re: Grading & Servicing Plan Review
Proposed Multi-Storey Building
1166 Bank Street – Ottawa, Ontario

file: PG6191-MEMO.02

Figure 1 - Servicing Plan Review

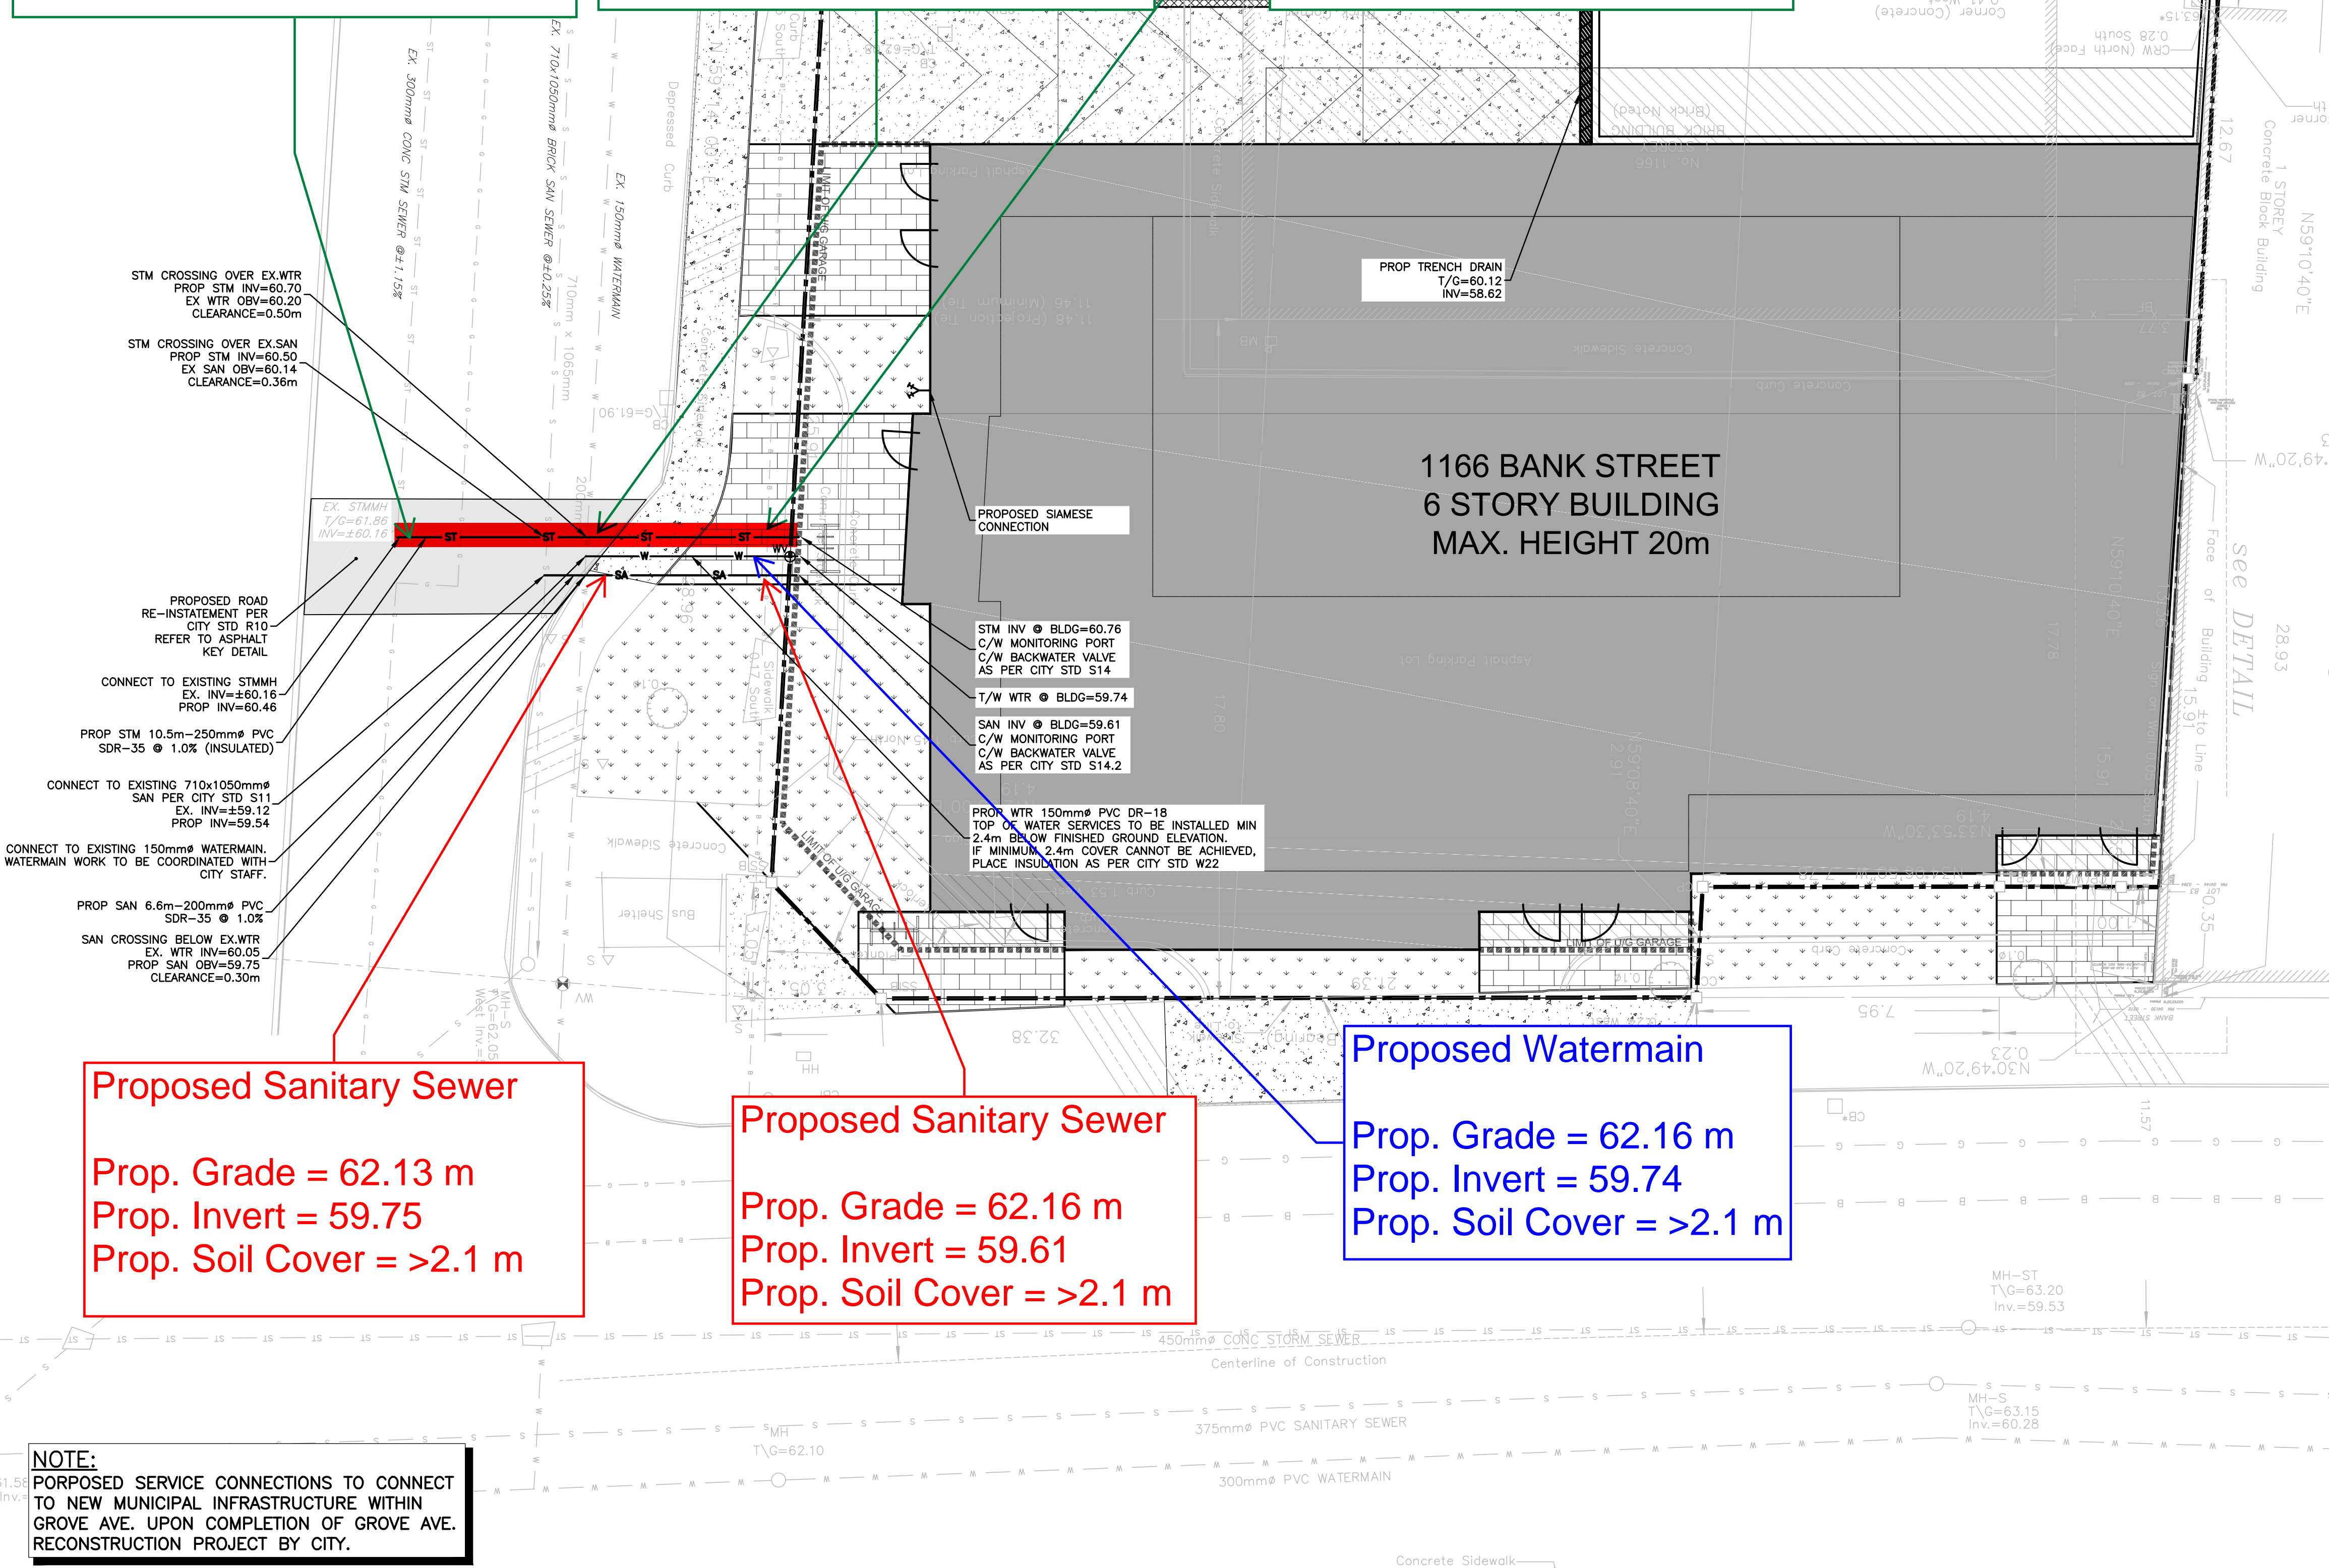
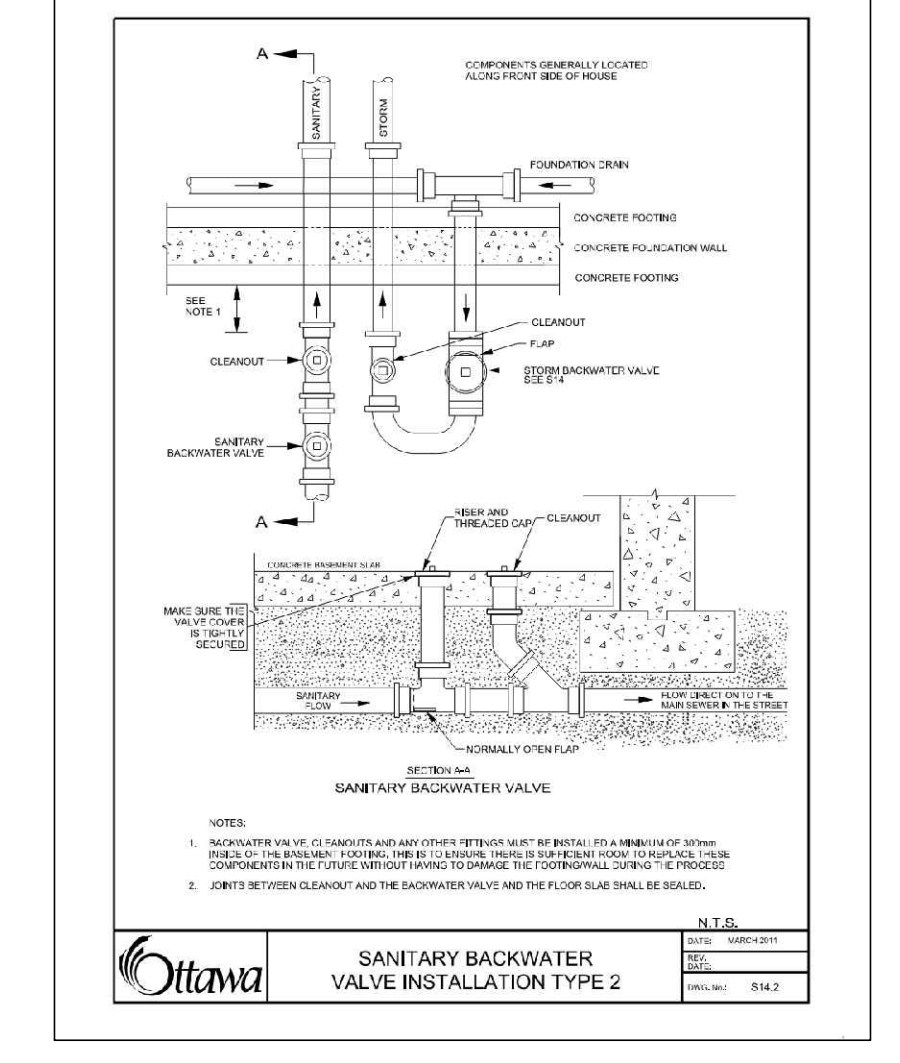
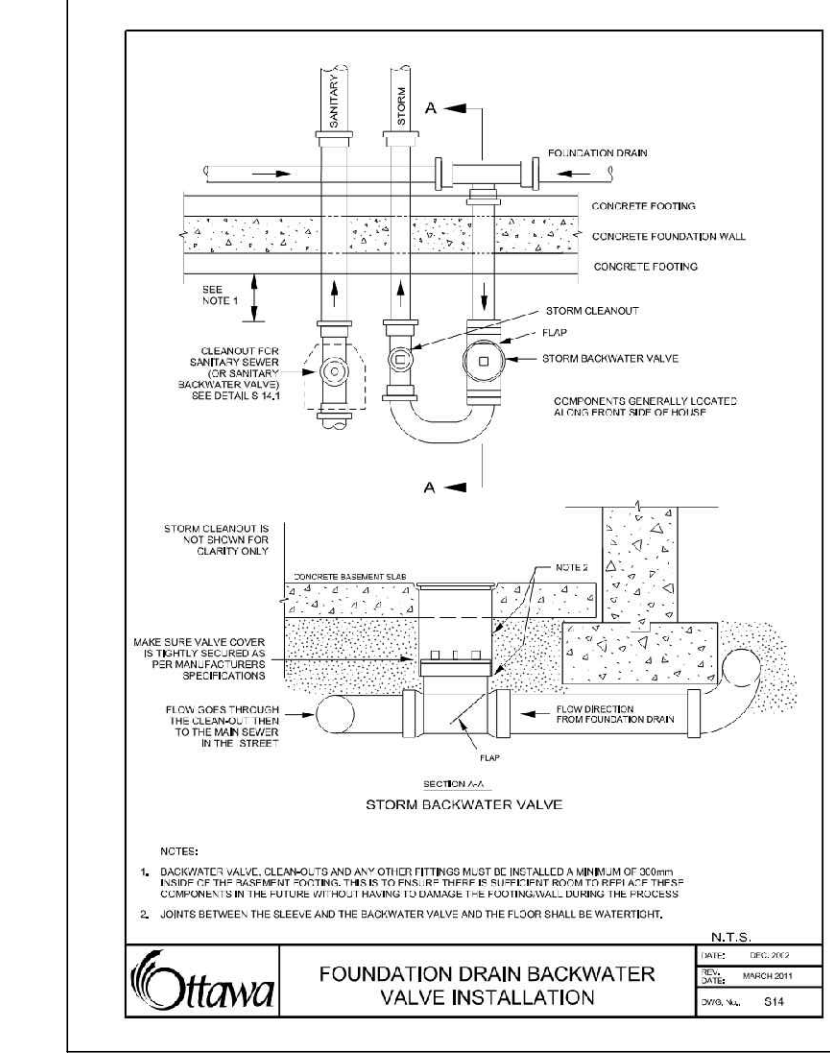
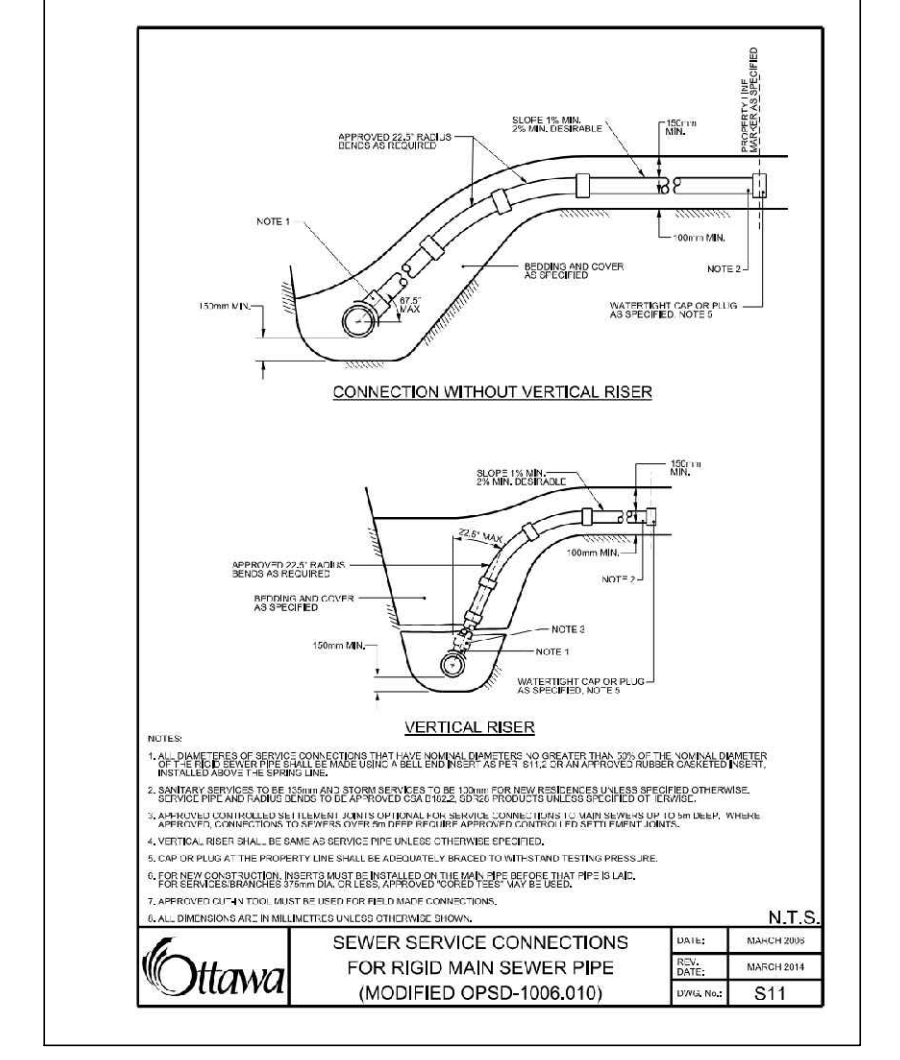
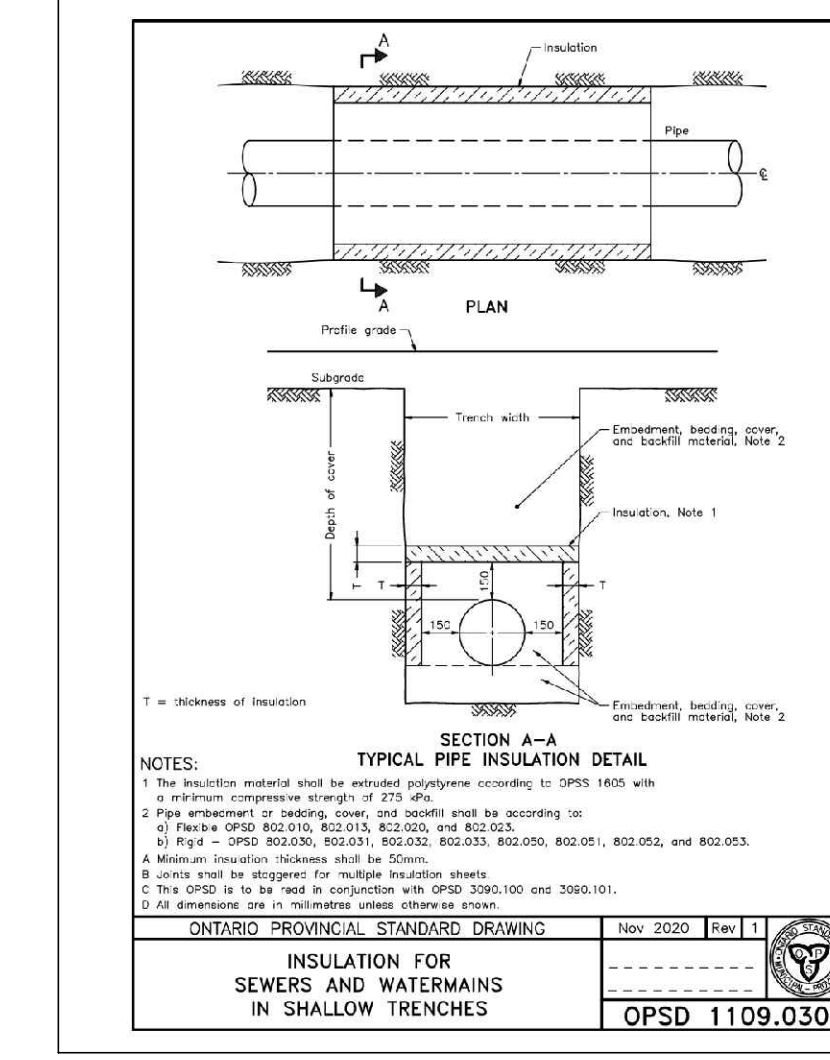
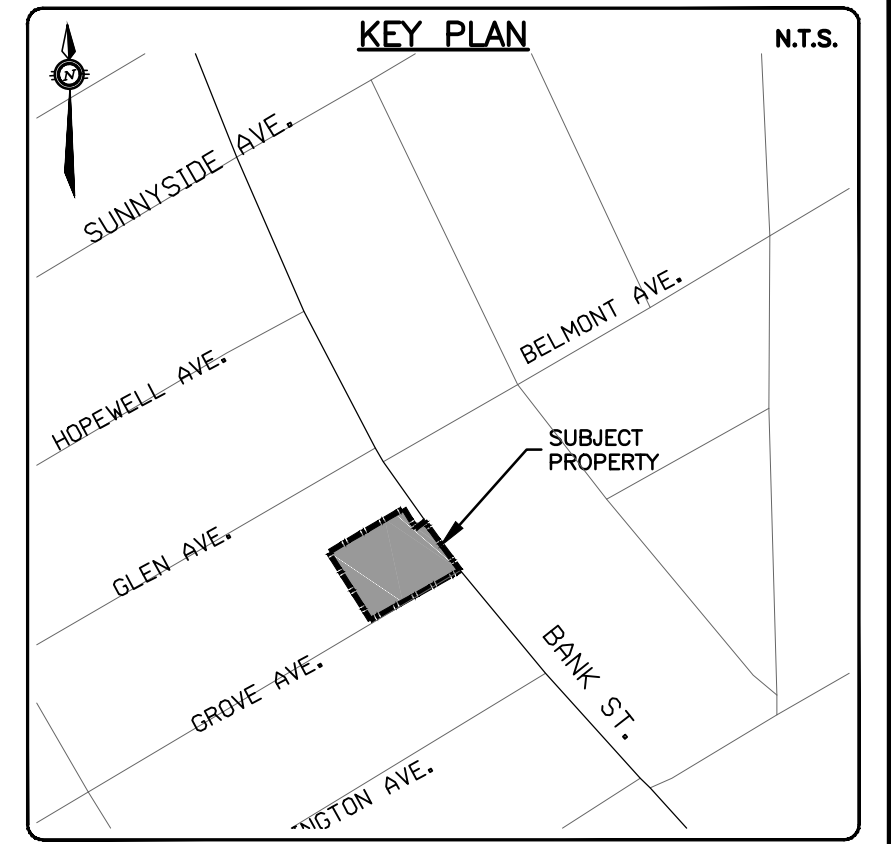
Based on our review of the site servicing plan, sufficient soil cover has been provided to the proposed watermain and sanitary services. However, insufficient soil cover was noted to be provided to the proposed stormwater service. Where insufficient soil cover (i.e. less than 2.1 m of soil cover is present above the obvert of the pipe) is available, the following frost protection criteria outlined in Table 1 should be followed. Please refer to Figure 1 – Servicing Plan Review attached which indicates the frost protection provided to each service.

Proposed Stormwater Sewer

Ex. Grade = 61.86 m
 Prop. Invert = 60.46
 Prop. Soil Cover = < 2.1 m

Proposed Stormwater Sewer

Prop. Grade = 62.13 m
 Prop. Invert = 60.70
 Prop. Soil Cover = < 2.1 m

Proposed Stormwater Sewer

Prop. Grade = 62.16 m
 Prop. Invert = 60.76
 Prop. Soil Cover = < 2.1 m

Table 1 - Rigid Insulation Recommendations for Storm Sewer and Water Pipes with Reduced Soil Cover			
Thermal Condition	Soil Cover Provided (mm)	Insulation Dimensions	
		Thickness (mm)	Extension (mm)
Unheated	600 to 900	125	Extend 1200 mm horizontally beyond edge face of the pipe
	900 to 1200	100	Extend 1200 mm horizontally beyond edge face of the pipe
	1200 to 1500	75	Extend 900 mm horizontally beyond edge face of the pipe
	1500 to 1800	50	Extend 600 mm horizontally beyond edge face of the pipe
	1800 to <2100	25	Extend 300 mm horizontally beyond edge face of the pipe

All rigid insulation should consist of either Dow Chemical High-Load 40 (HI-40), Styro Rail SR.P400, or equivalent approved by Paterson. The placement of all insulation within the service trenches must be reviewed and approved by Paterson personnel at the time of construction.
